Lewisham Cyclists (local borough group of the London Cycling Campaign) response to Transport for London Streetspace Plan - A21 Lewisham to Catford

06 November 2020

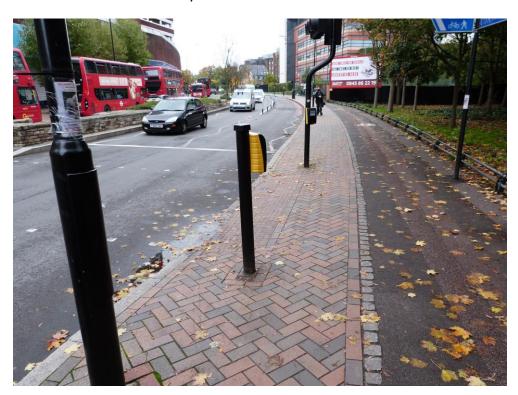
- 3. It's unclear to us how cyclists are meant to have priority on the northbound carriageway on Lewisham High Street on approach to Ladywell Road junction (see photos below). The current layout creates a potential conflict between left turning traffic and cyclists accessing the ASL. The water barriers appear to have been moved since installation so that cyclists are now

tending to go to the left of them placing them in a left hook position on what is a heavily used HGV route. We believe this layout should be reviewed and potentially changed.
